Technical Bulletin 86

UCI2 Radio Wiring Recommendation to Prevent Unintentional Keying of Transmitter

Version 1.2, Revision AB (5 January, 2001)

Universal Communications Interface 2 (UCI2)

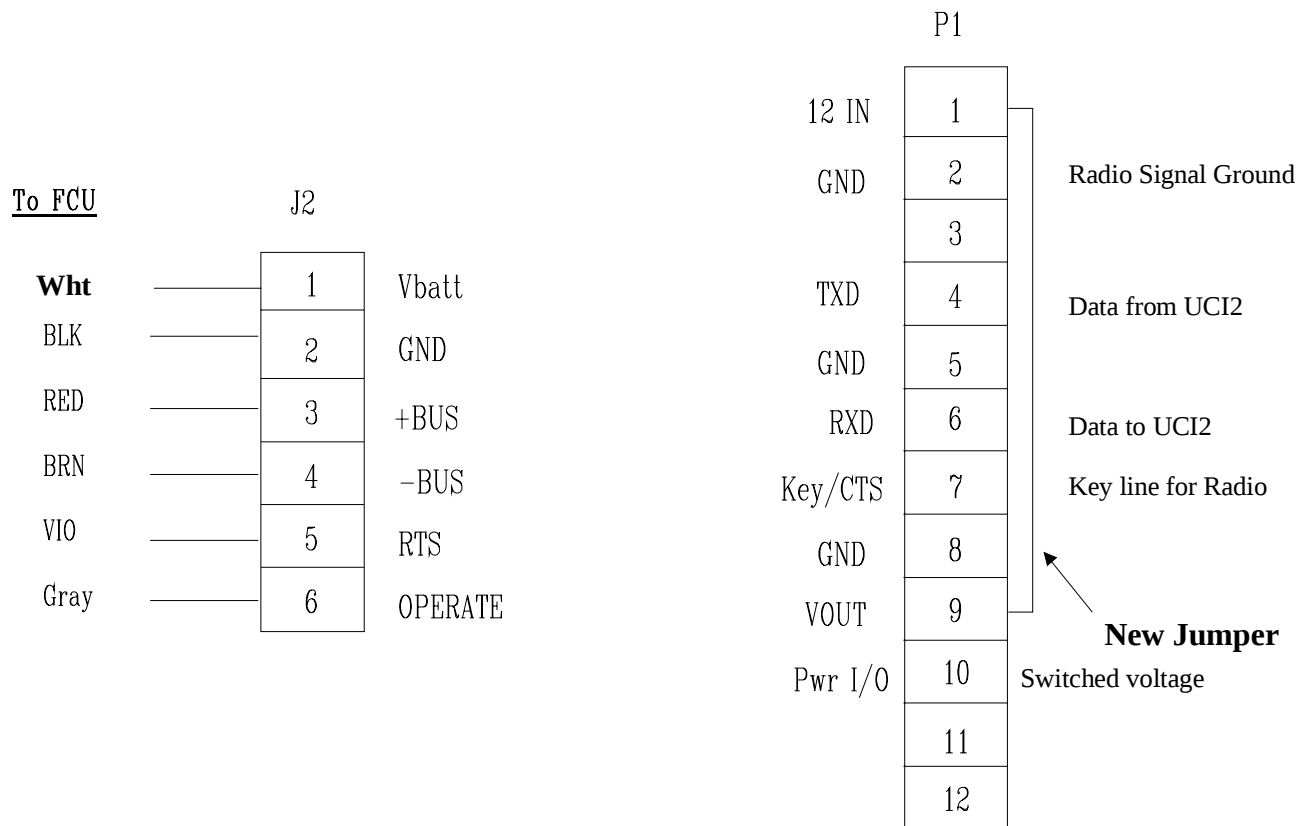
Wiring change when duty cycling a radio requiring a signal to key the transmitter (i.e. RTS)

Problem: The new UCI2 can cause a radio to key intermittently if the UCI2 is allowed to duty cycle based on Totalflow's 1, 2, or 4 second communications protocol.

Original Documentation: The original documentation allowed the option to either continuously power the UCI2 or to duty cycle power to the UCI2. Duty cycling was achieved by connecting "Operate" (Pin 6 of J2) line of the UCI2 to the operate (model 6400/6700) or switched Vbatt (model 6600) of the Flow Computer. Duty cycling the UCI2 can cause the radio to "chirp" or intermittently key the transmitter.

Solution: Install a jumper between pins 1 and 9 on P1 of the UCI2. If you want to continue to duty cycle the radio, connect the power (Or the inhibit line when using certain MDS radios) from the radio to "Pwr I/O" (pin 10 of P1). The "Pwr I/O" connection will continue to duty cycle as directed by the "Operate" signal.
